# Department of Environmental Quality

RE: Minerals Exploration A-3 In Situ Site  
DEQ/LQD License to Explore No. 17

SUBJECT : Analysis of Recent Water Quality Data from  
Wells at the A-3 In Situ site; Acceptability of  
Restoration Work

$U_3O_8$ , Wells 1A-4A

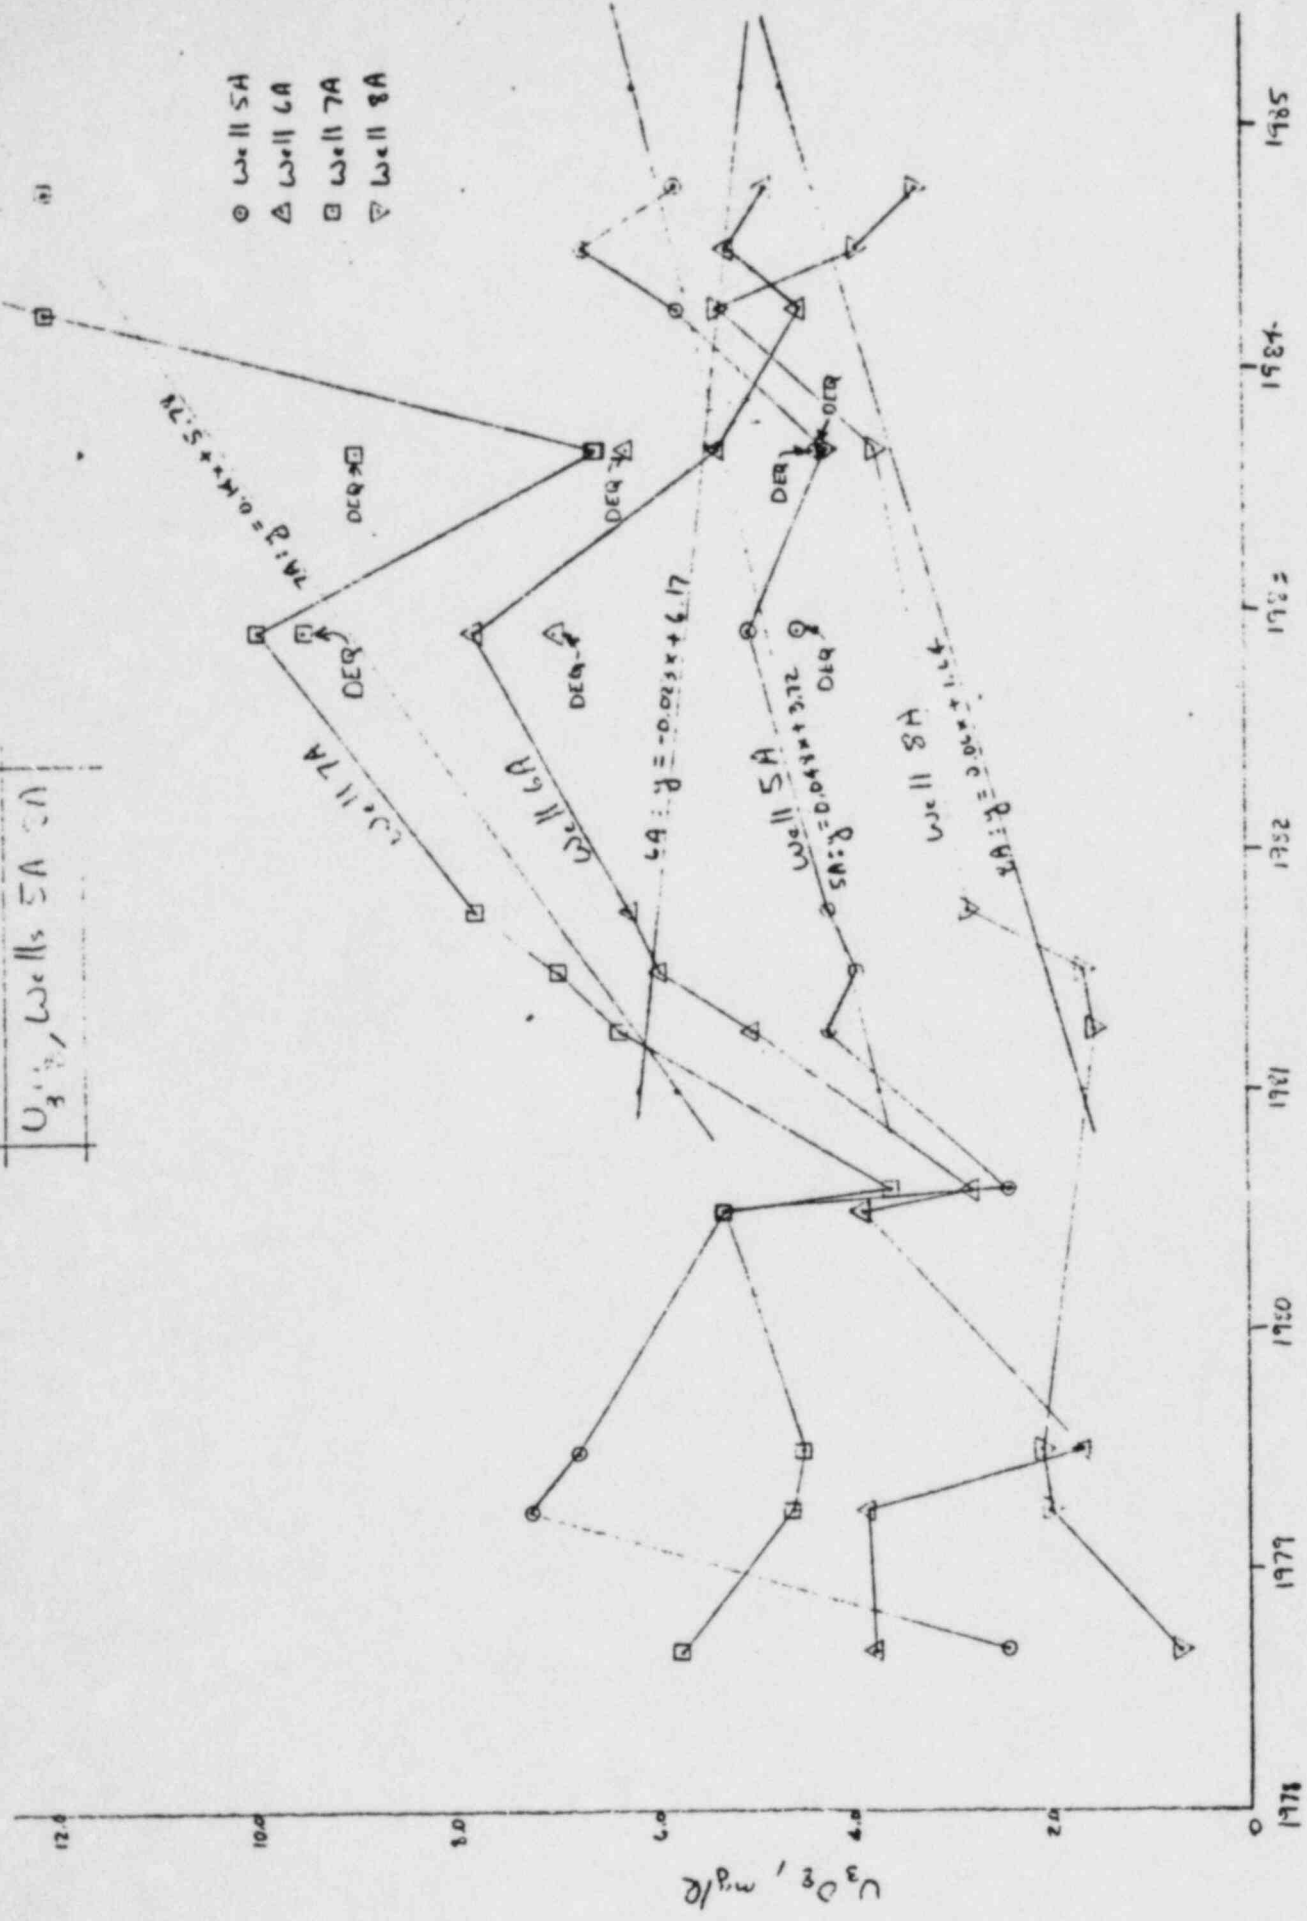
Using MEC data (see attached data sheets), linear regressions were performed for each A Field well for data starting in 1981\*. Attached are two graphical plots of MEC's uranium data plotted vs. time, along with the fitted lines. Below are the equations with the 95% confidence intervals for the slopes:

As may be seen, the trends for the data show clearly an increasing uranium concentration trend. This is true for five of the eight A Field wells, for the averaged A Field data and for averaged B Field data. Furthermore, for the fitted lines for averaged data for both fields, it can be stated with 90 +% confidence that the slopes are positive (i.e.,  $U_3O_8$  increasing with time).

It is possible that very recently uranium began trending downward. This was evaluated on a well by well basis for the A Field for MEC data collected since January 1983. If anything, this showed a higher rate of increase in  $U_3O_8$ , which is readily evident on the graphs. Well Field B MEC data was not analyzed on a well by well basis, but it is readily evident from the data plots that the recent trend (since January 1983) is up.

Ra-226, Well 1A-4A

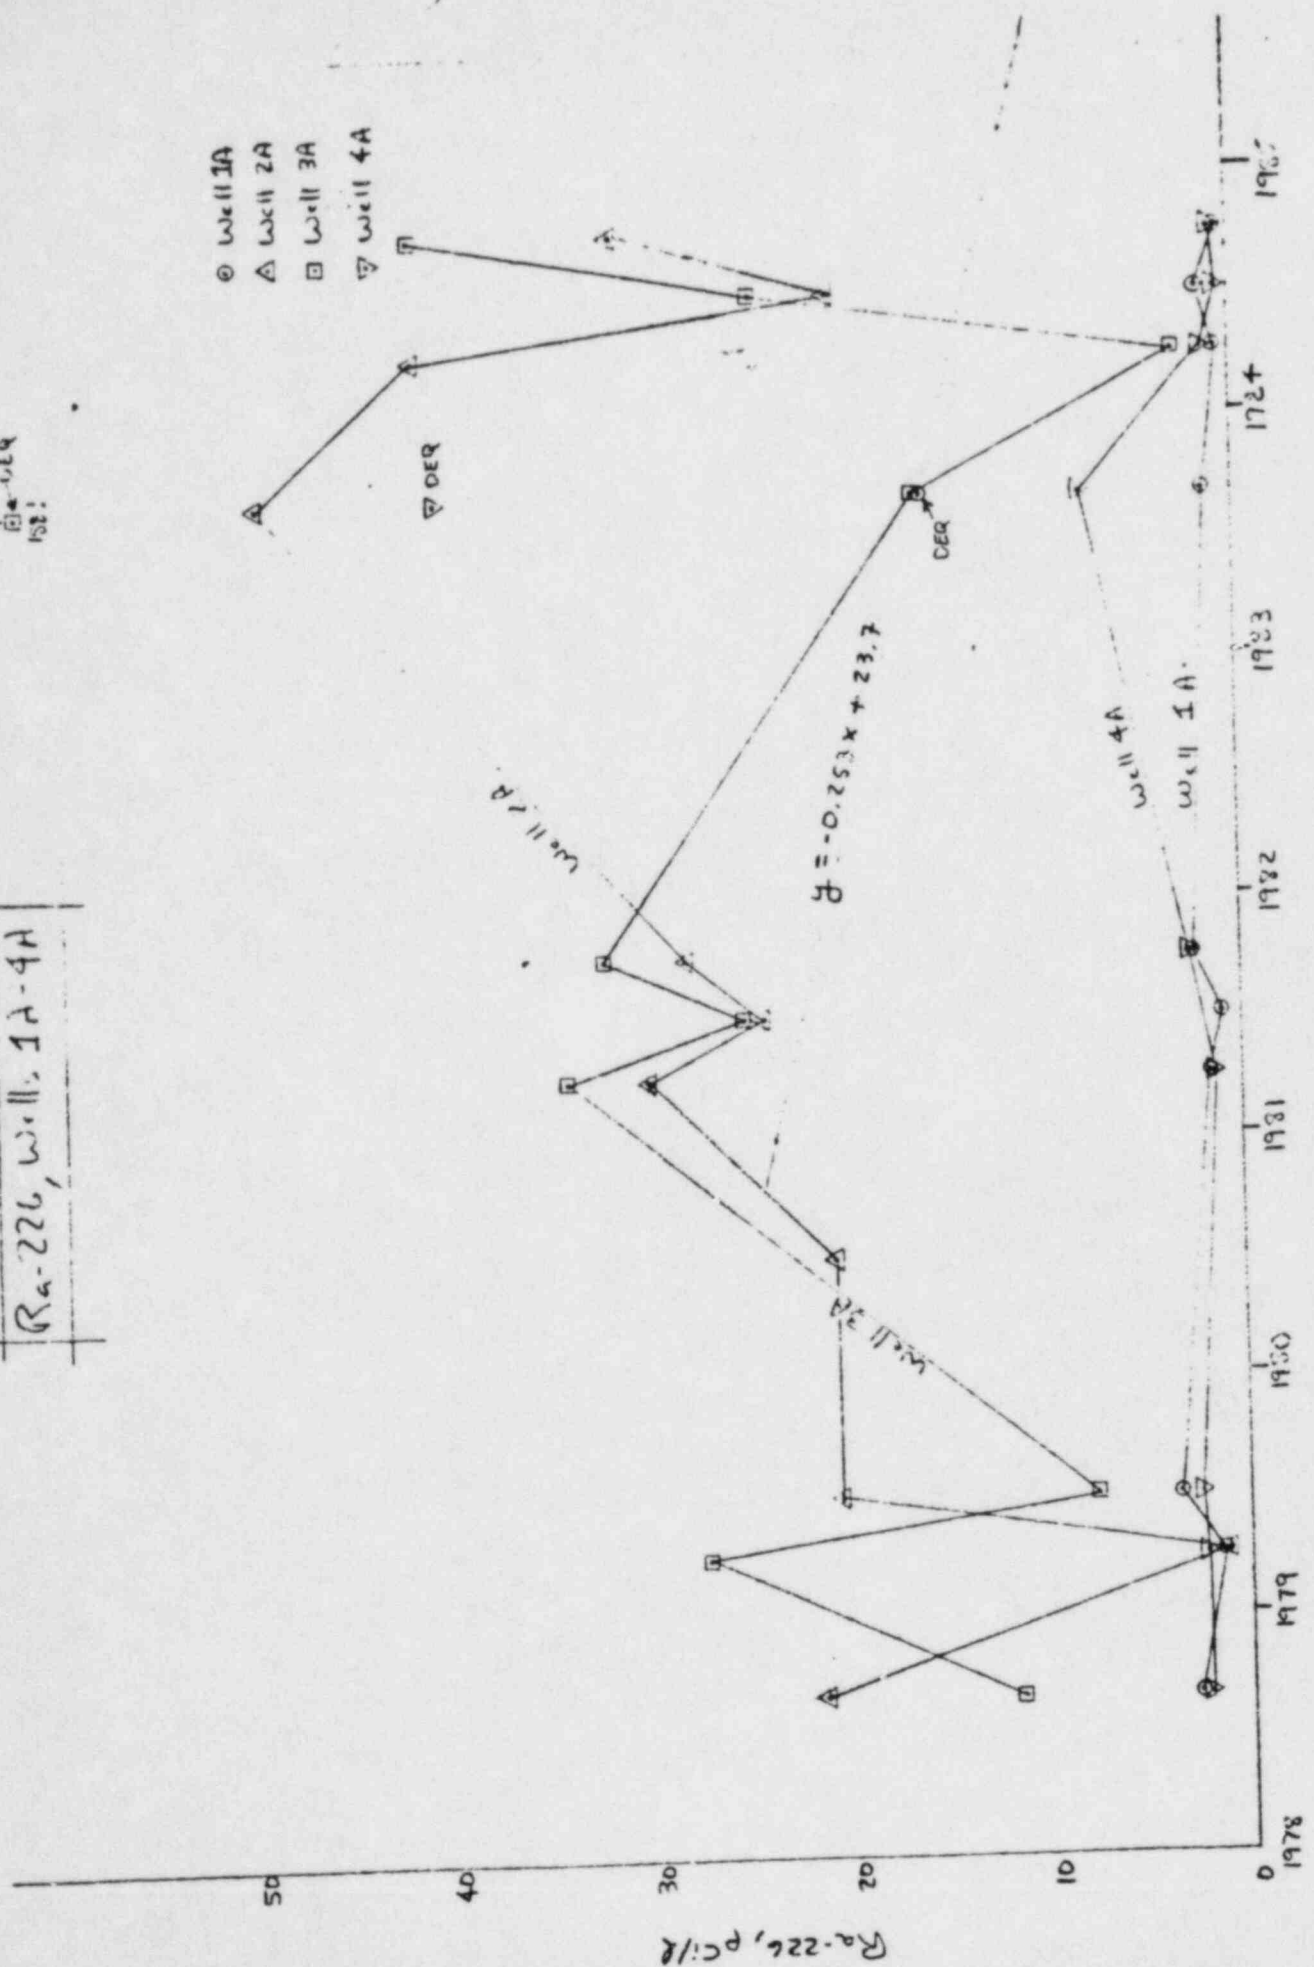
Radium concentration trends were analyzed for Fields A & B as a whole. In each case, data from January 1981 to present was used, averaging all sample results from a given sampling date.

which is plotted on the A Field radium plot.

It may therefore be said with 95% confidence that radium concentrations in the A Field as a whole have been decreasing since January 1981.
